MASTER DEVELOPMENT PLAN

SADDLE MOUNTAIN AT OAKSTONE  
SAN ANTONIO, TEXAS

MDP ID # 865

**City of San Antonio**  
**Development Services Department**  
**Master Development Plan**  
**APPLICATION**

35-B101(c)

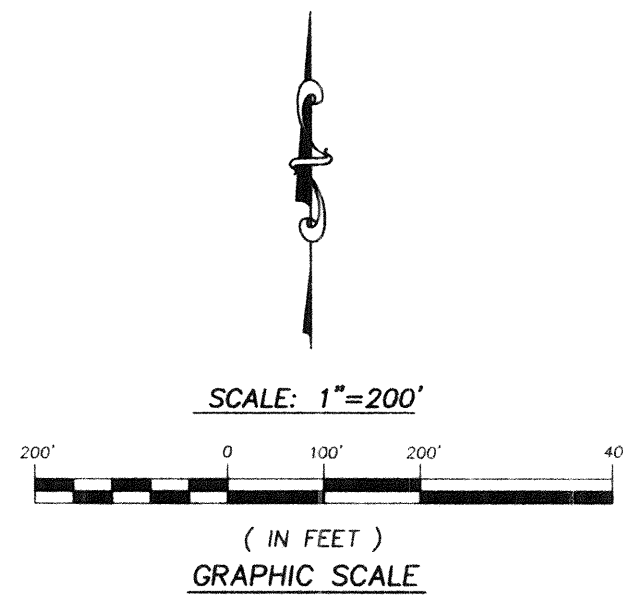
SHOW  
DRIVEWAYS  
35-B101(c) F(14)

MASTER DEVELOPMENT PLAN

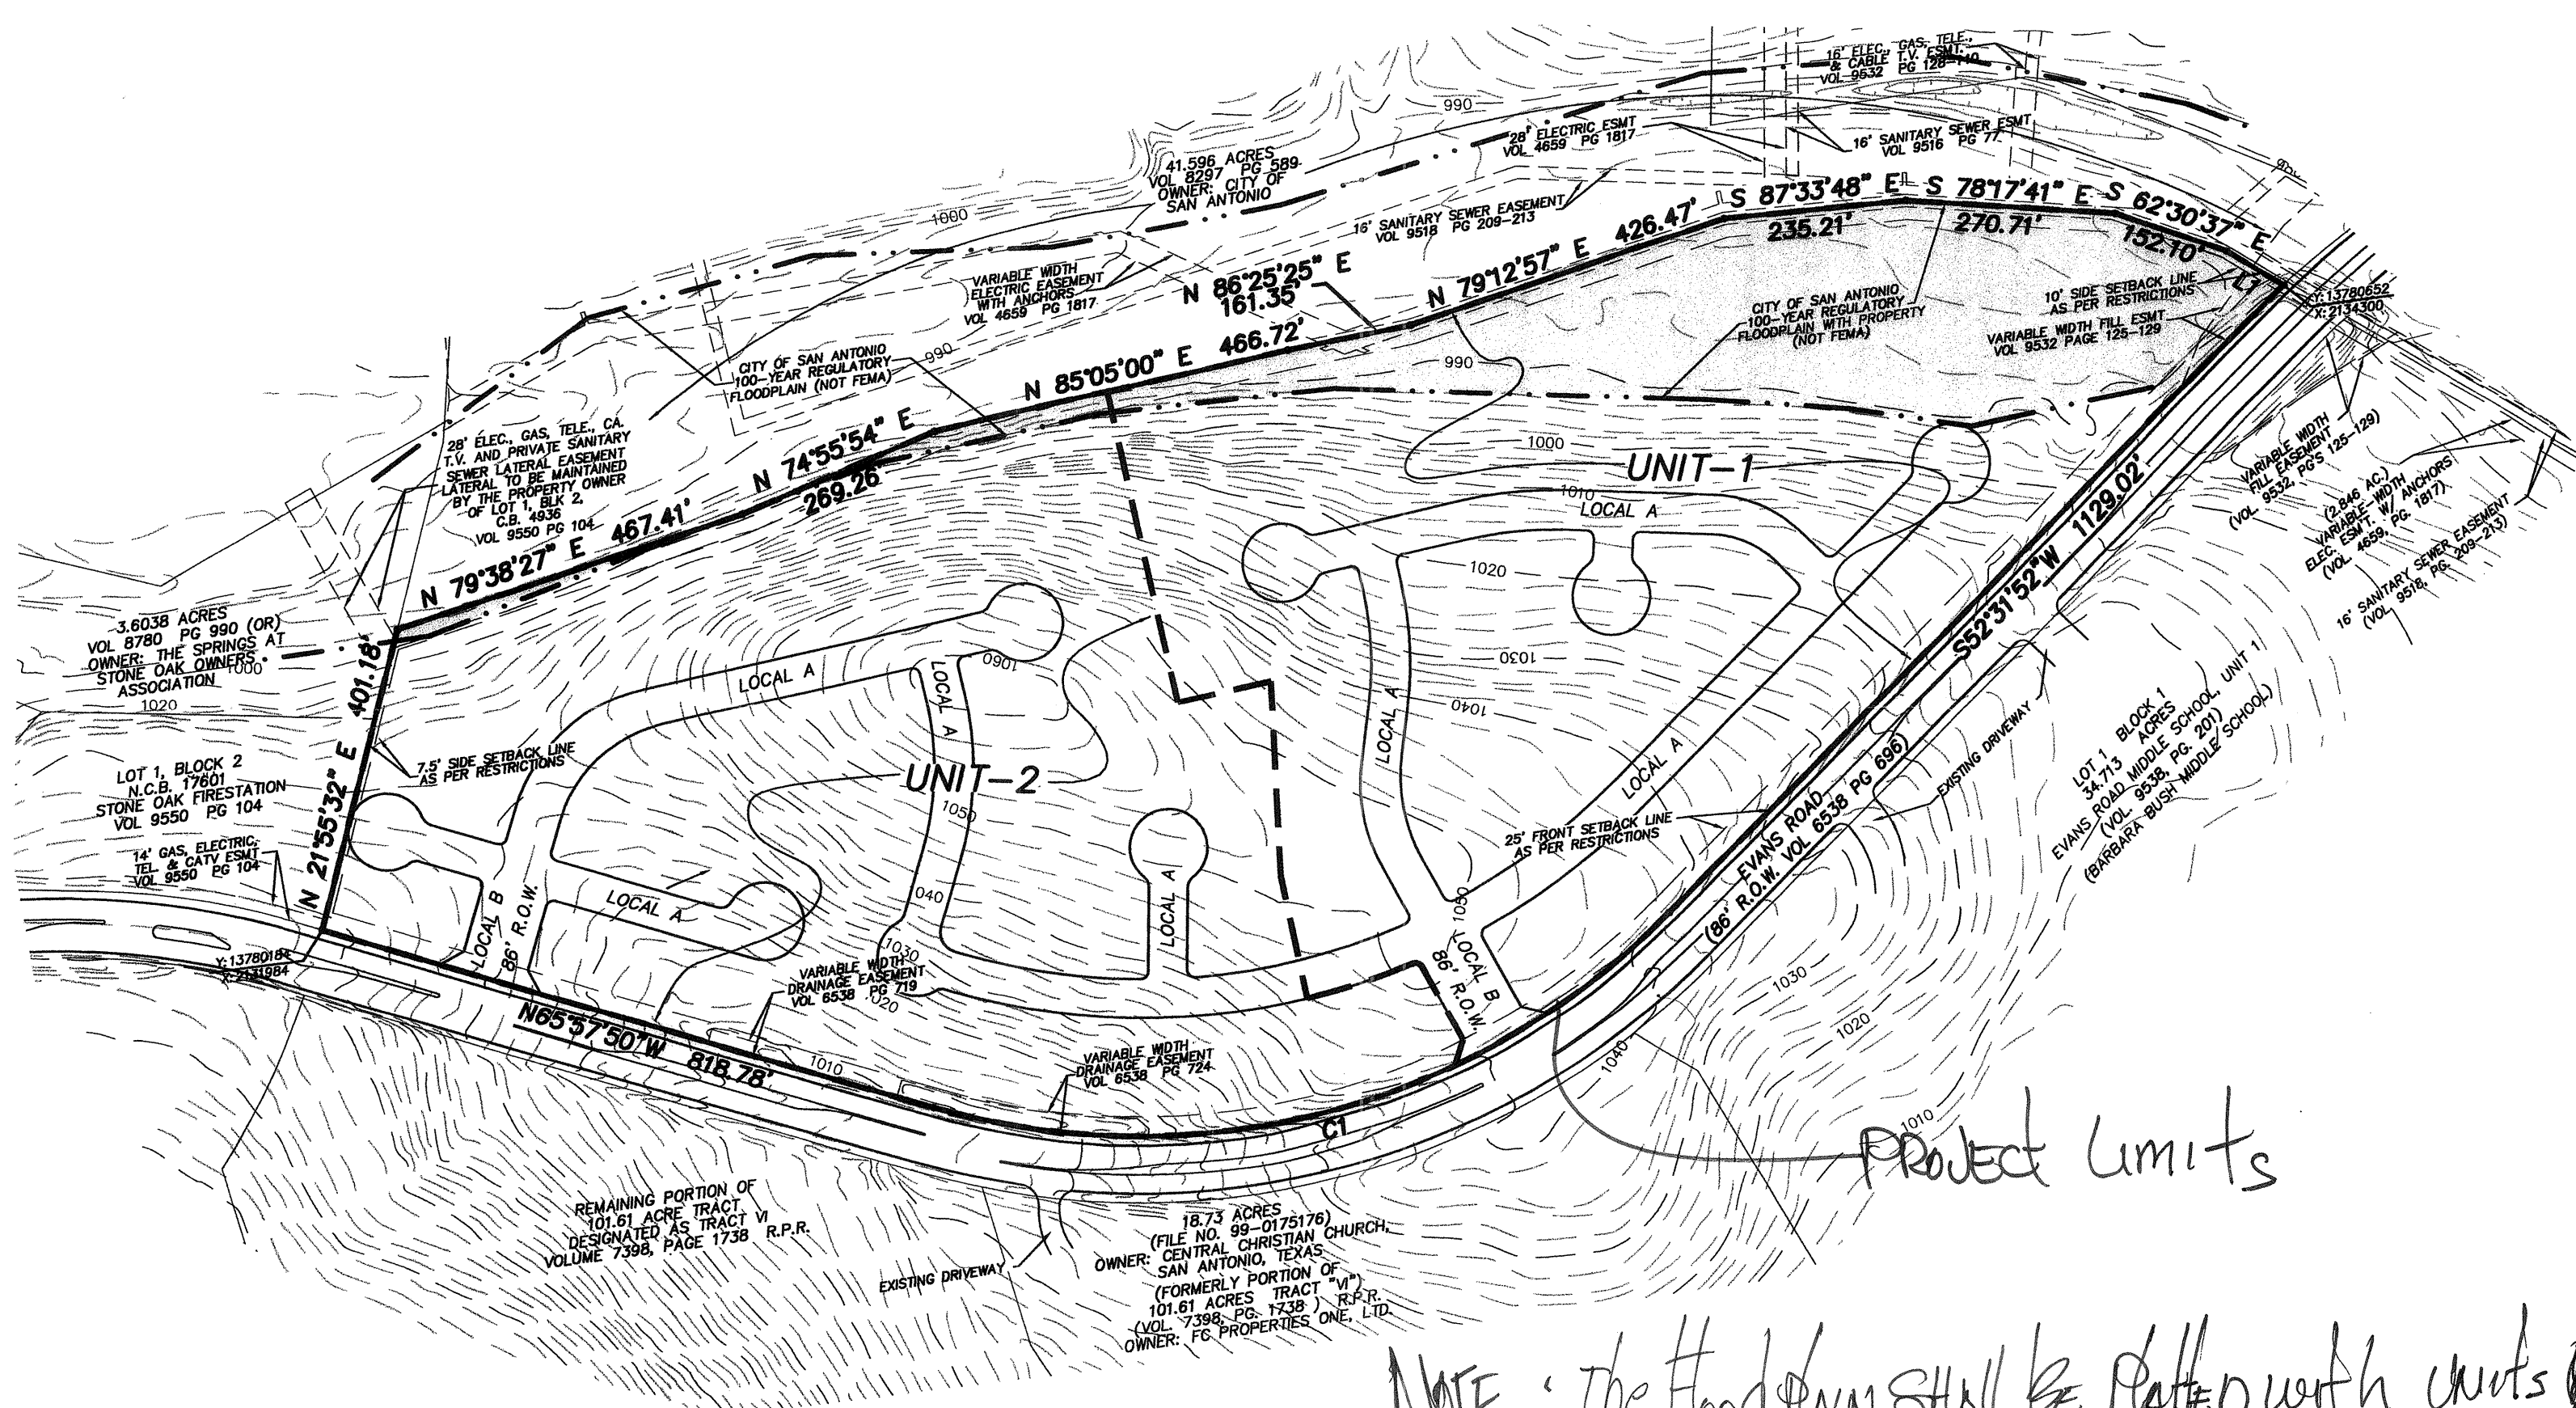
- ~~1. PROVIDE LEGAL INSTRUMENT~~
2. PROVIDE VRP AND SHOW VRP NUMBER ON PLANS
3. LABEL PROJECT LIMITS
4. PLACE NOTE ON MDP: "THE FLOOD PLAIN SHALL BE PLATTED WITH UNIT 1/2 AT THE TIME OF PLATTING"
5. SHOW DRIVEWAYS ON OBISITE SIDE OF EVANS RD. <sup>EAST</sup>
6. CLEAN UP THE AREA AT THE CORNER OF THE PROJECT WHERE THE COORDINATES ARE SHOWN.

- 1. Provide a copy of the VRP, and show the VRP Number on the Plans.**
- 2. Label Project Limits.**
- 3 Place Note on the Plans: "The flood plain shall be Platted with Unit 1 and 2 at the time of Platting."**
- 4. Show driveways on the opposite side of Evans.**
- 5. Clean up the area the east corner of the project where coordinates are shown.**

3. SHOW the dimensions of and approximate locations of all existing culvert (and/or low-water) crossings. There appears to be a crossing to the west of the Barbara Bush Middle School entrance.
4. ADD "flow direction arrows" to illustrate approximate flow paths [across lots as well as with drainage easements].
5. SHOW the approximate location of proposed lots within each master planned development unit.

6. SHOW the approximate locations of drainage easements required to BOTH direct runoff to the 100-year floodplain AND to contain the 100-year floodplain.
7. EXTEND the "unit divide" boundary through the 100-year floodplain.
8. VERIFY that and ANNOTATE that the floodplain is the Regulatory (100-year ultimate development) floodplain.

- Grades are shown to be greater than the 12 and 15% limits of the UDC 35-506(d)(3). Grades shall comply with UDC 35-506(d)(3) at time of platting.
- Change Note 2: "Sidewalks shall be installed along all internal and external roadways in accordance with UDC 35-506(q)."
- Add Note: All intersections shall be provided with clear vision area in accordance with UDC 35-506(d)(5)."

A rezoning case is pending for the eastern portion of the property included within this MDP's boundaries. I can review a resubmittal following City Council's action on the rezoning request. To that end, a note on the MDP indicates that the proposed zoning is R-5. However, the rezoning case is only for a portion of the property and the request is to change it to R-6. Also, any zoning labels need to include the "ERZD" overlay.

This Master Development Plan requires a revision to the Tree Requirements Note. Please remove the text stating that the streetscape requirement is exempt due to vesting. Streetscape requirements cannot be vested and this project will need to comply with streetscape requirements along Evans Road.

THIS PROPERTY IS VESTED FROM THE 1997 TREE PRESERVATION, 2003 TREE PRESERVATION REQUIREMENTS. STREETSCAPE REQUIREMENTS WILL BE MET ALONG EVANS ROAD AND THE TWO ENTRY STREETS UP TO THE FIRST INTERSECTION ON EACH STREET.

- ALL STREETS SHOWN HEREIN ARE CONVENTIONAL PUBLIC LOCAL TYPE "A" WITH 50' RIGHT OF WAY AND 28' OF PAVEMENT, UNLESS OTHERWISE INDICATED.
- SIDEWALKS SHALL BE INSTALLED ALONG ALL INTERNAL AND EXTERNAL ROADWAYS IN ACCORDANCE WITH UDC 35-506(g).

- THE SITE IS VESTED FROM THE CONNECTIVITY RATIO STANDARDS.
- ON APRIL 19, 2005, THIS PROJECT WAS APPROVED FOR A VESTED RIGHT PERMIT AS ON JUNE 5, 1985 FOR APPROXIMATELY 180 SINGLE FAMILY DWELLINGS. VESTED RIGHT PERMIT NUMBER IS 05-03-072.

- THE CITY OF SAN ANTONIO 100 YR REGULATORY FLOODPLAIN SHALL BE PLATTED AS A DRAINAGE EASEMENT WITH UNIT 1 AND 2 SUBDIVISION PLAT.
- ALL INTERSECTIONS SHALL BE PROVIDED WITH CLEAR VISION AREA IN ACCORDANCE WITH UDC 35-506(d)(5).

NOTE: The Floodplain shall be Platted with units 1 and 2 at the time of platting

DATE	NO.	DESCRIPTION	REVISIONS
9/20/05	4	REVISED NOTE 2 & ADDED NOTE 18 PER STRT & SAN COMMENTS. REVISED ZONING INFO PER ZONING COMMENTS.	
9/6/05	2	LOCAL "B" STREET SECTION TO SHOW BICYCLE & PEDESTRIAN PATH.	
8/4/05	1	ADDED NOTES PER STORM WATER COMMENTS 8/7/05

NON-STANDARD STREET SECTIONS  
LOCAL B -- 2-22' Asphalt Section in 86' Right-of-Way  
(VIEW ENTRANCES)

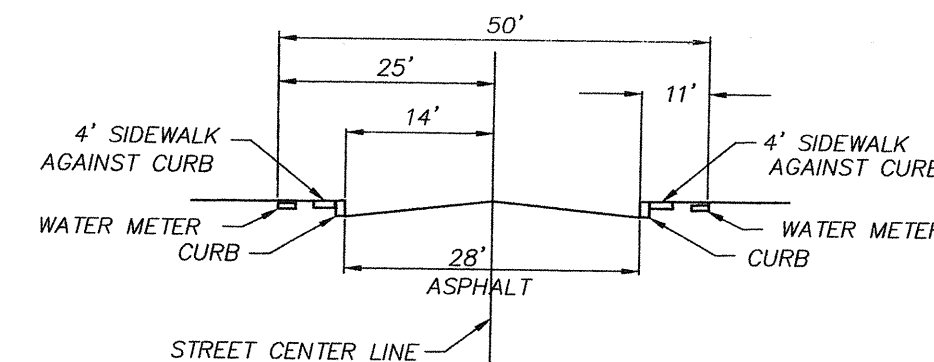
Handwritten notes: "Please see P. 101 and 102 for more details and show NUMBER ON PLAT".

The street design for 86' roadways should show bicycle facilities as required by ordinance and UDC.
